## **IMPORTANT SAFETY RECALL – 16V-477**

## Safety Notice

## SN642

SUBJECT: Hydraulic cylinder

Figure A. Hydraulic Cylinder Location

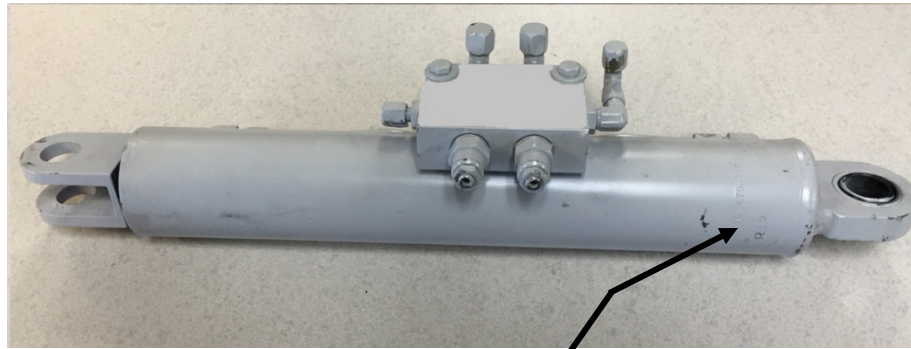
Using figure A, locate the hydraulic cylinders for the leveling and jib functions. Boom tip covers will need to be removed to inspect the jib articulation and jib extend cylinders. Using figure B, inspect the date code on the hydraulic cylinder. Note that some units will not have a hydraulic extend jib cylinder.

Figure B. Hydraulic Cylinder Date Code

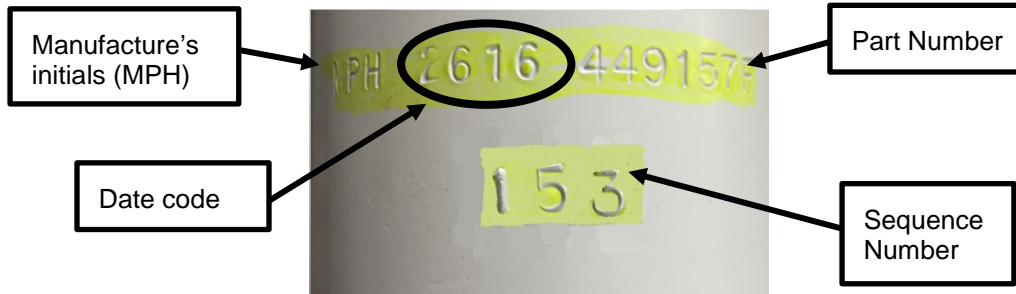
The first two numbers in the date code are the week the cylinder was manufactured. The second two numbers are the year the cylinder was manufactured. Example 2616 was manufactured week 26 in 2016 (June 27<sup>th</sup>, 2016). Sequence number 153 represents this was the 153<sup>rd</sup> cylinder manufactured in week 26 in 2016.

**Any MPH hydraulic cylinder that has a date code between 1316 and 2416 (March 28<sup>th</sup>, 2016 through June 17<sup>th</sup>, 2016) with the following part number stamped in the case is subject to the recall and will need the hydraulic cylinder replaced.**

**Cylinder part numbers: 449154, 449157, 457545, 475781, 479473, 479573, 604468, and 614140**
